**JUPITER INLET COLONY
BUILDING AND ZONING COMMITTEE MEETING
07.30.20**

RE: 193 Shelter Lane, Jupiter Inlet Colony FL 33469 - Zoning Narrative

RE: 193 Shelter Lane, Jupiter Inlet Colony, Florida 33469 – Lot 193

Re: *Jupiter Inlet Colony*
 193 Shelter Lane
 Lot Drainage Plan Review

2

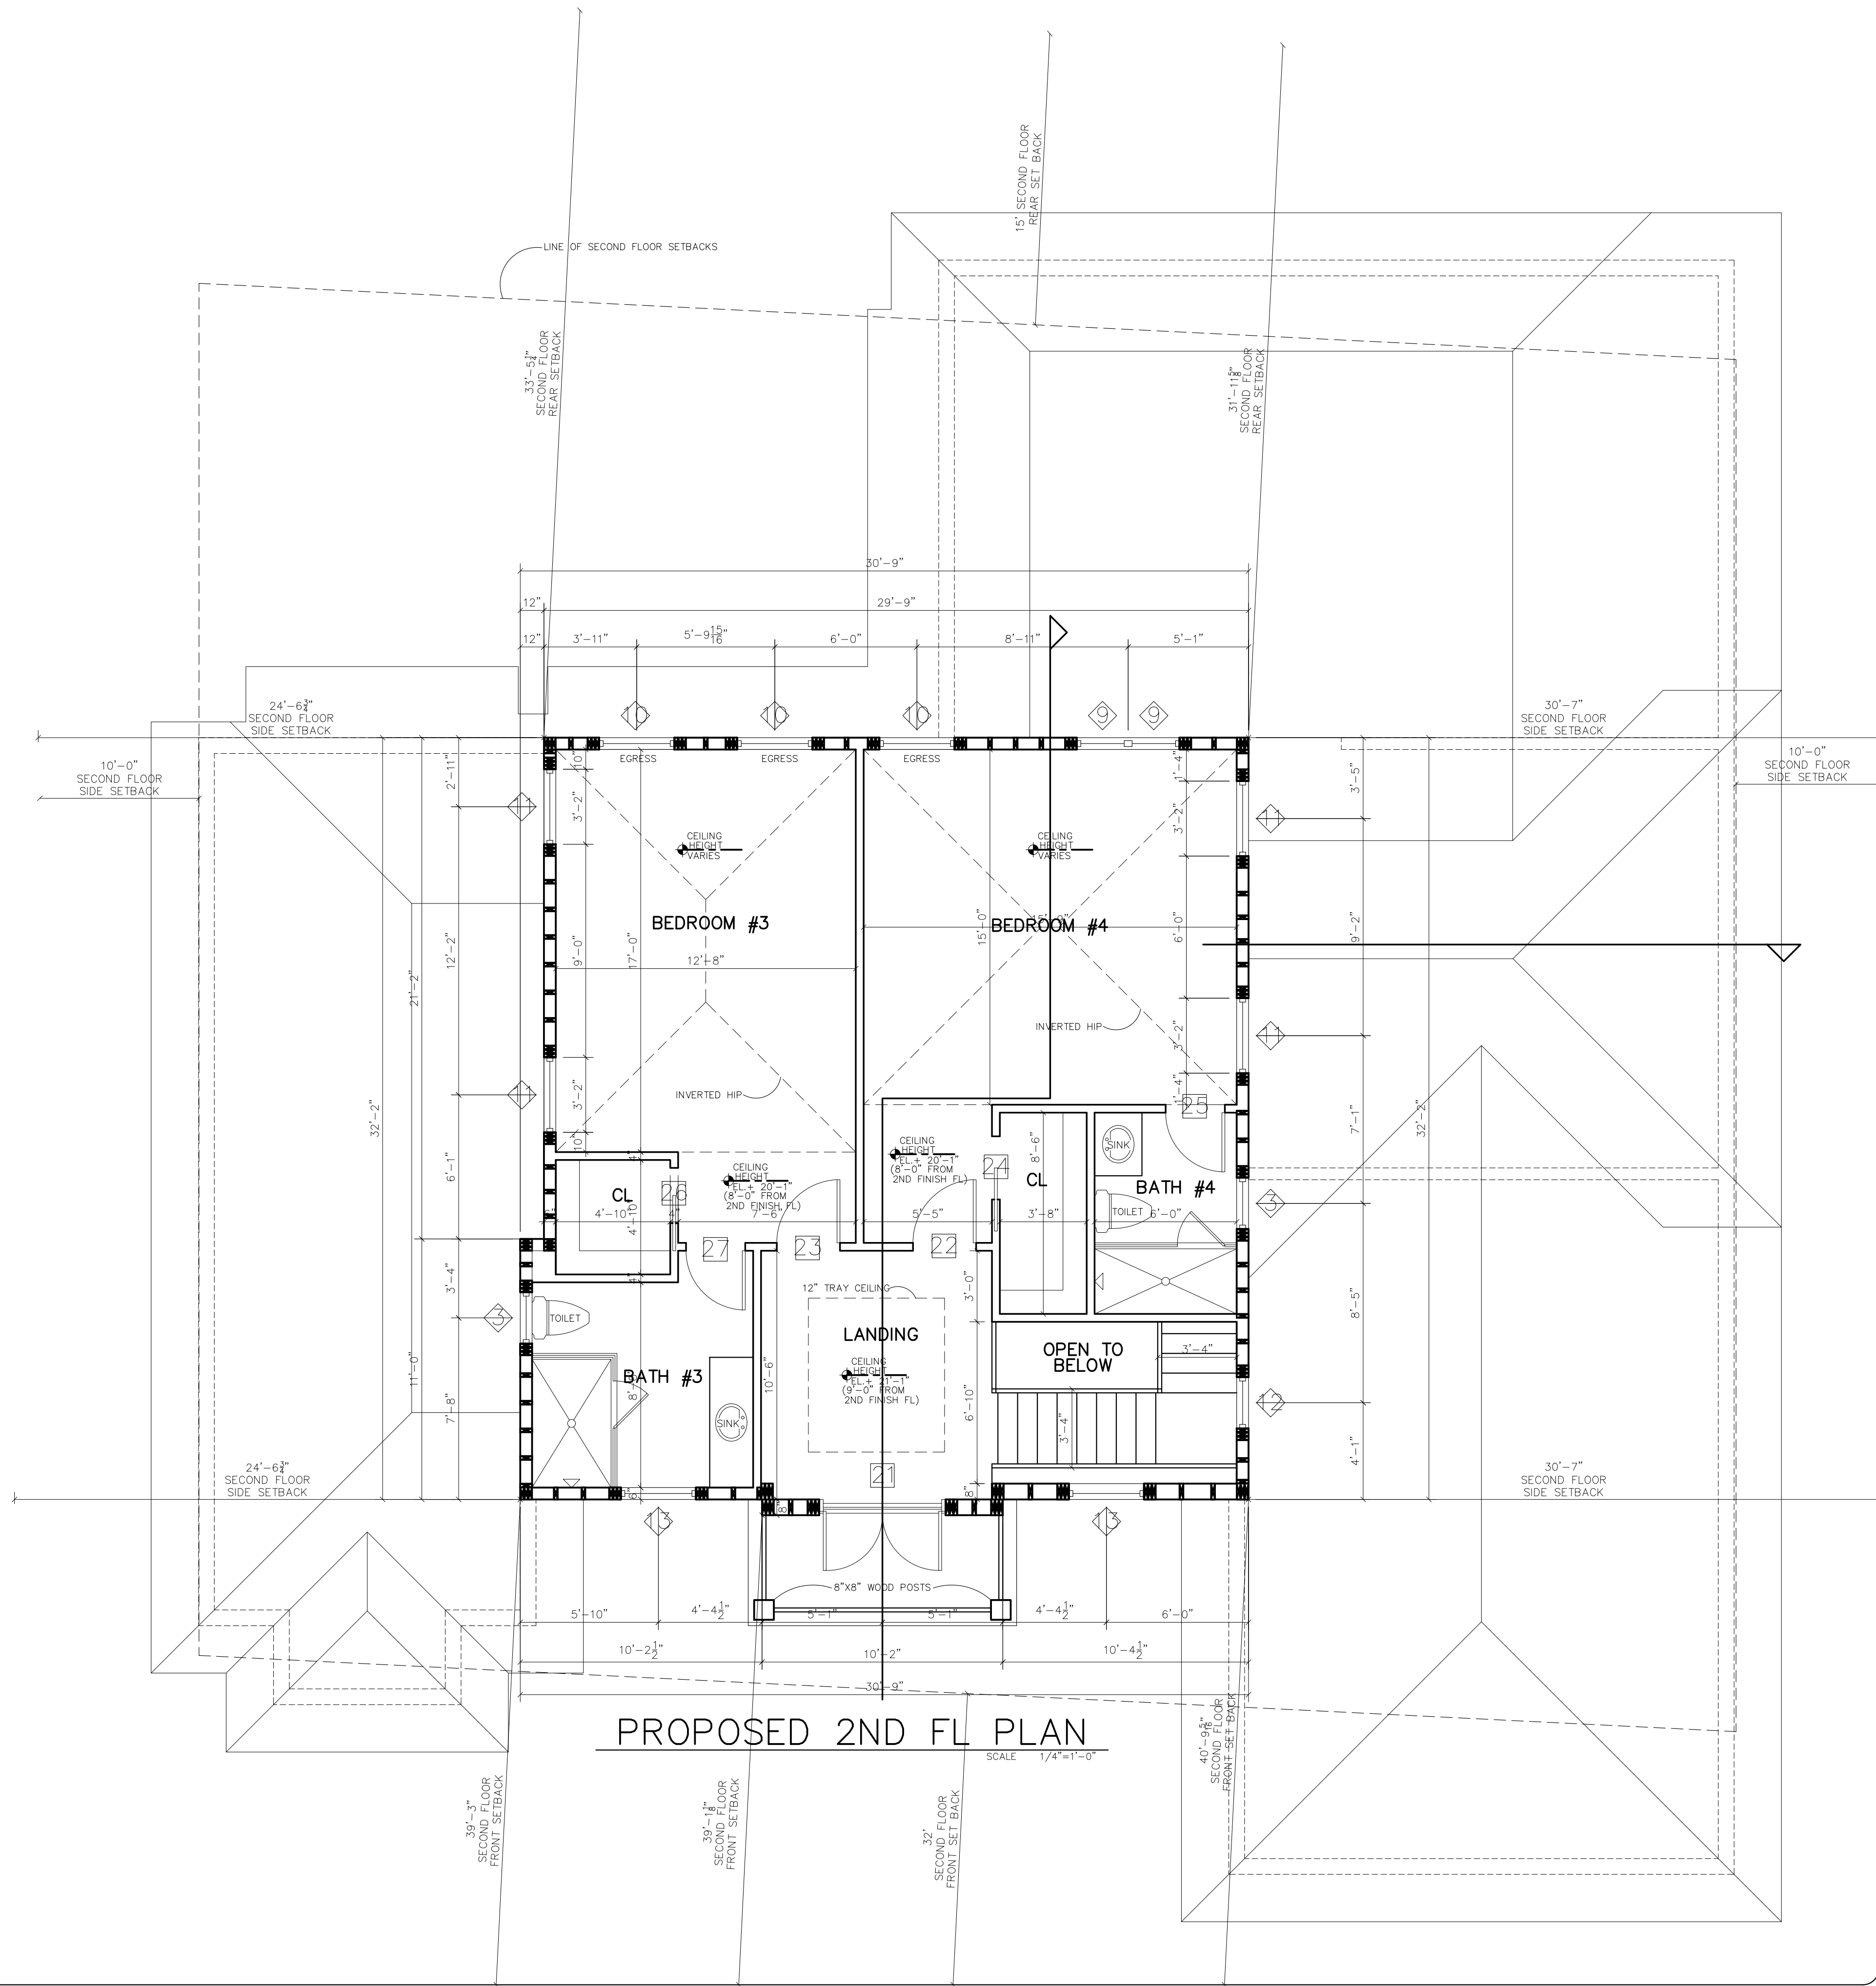
- Please add proposed grades to the plans as indicated on the red lines in the area around the new pool deck. Its not clear how the drainage pattern is in that area.
- They should probably address grades for the new walkway in front.
- Since this is a re-model, the finished floor remains the same, I added adjacent finish floor elevations for informational purposes.
- The drainage statement provided assurances that the existing grades will remain as is, and after construction of the home, the homeowner will need to restore to those grades accordingly.

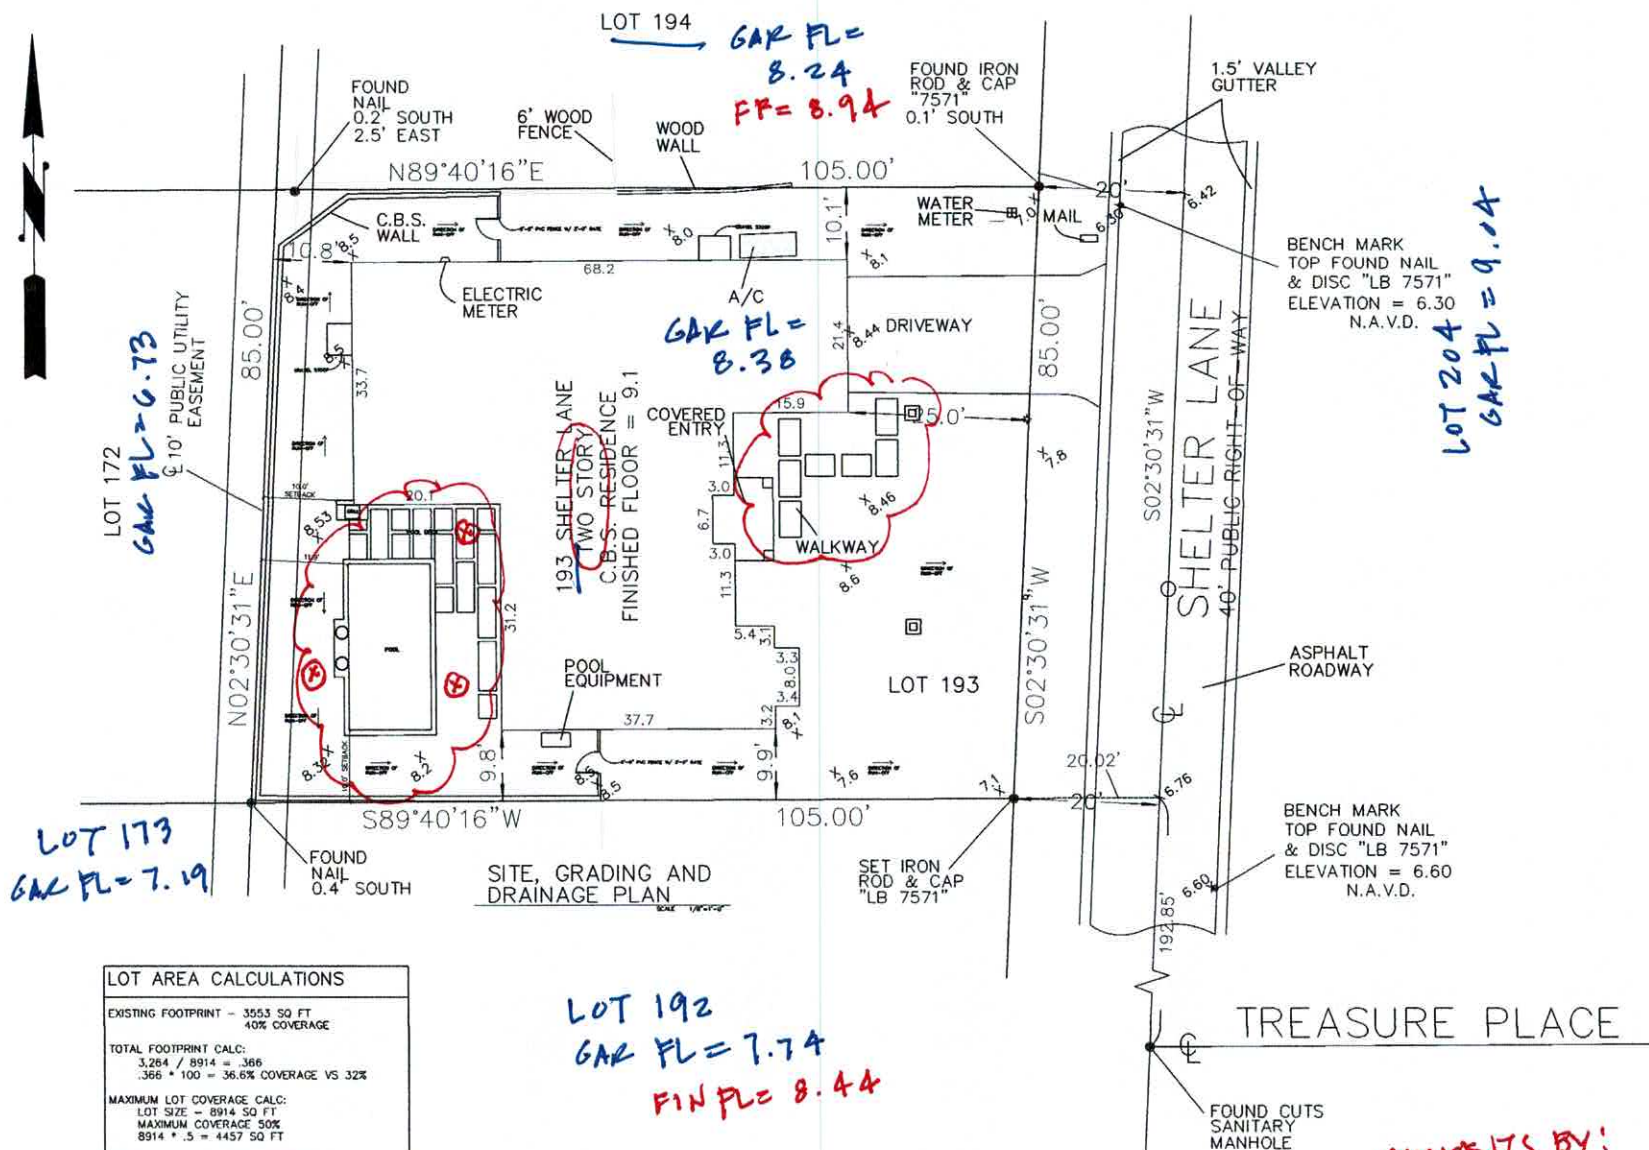
LOT 192
GAR FL = 7.74
FIN FL = 8.44
⊗ GRADE EL. ?

COMMENTS BY: 7.17.17
Thomas C. Jensen
THOMAS C. JENSEN, PE.
COLONY ENGINEER
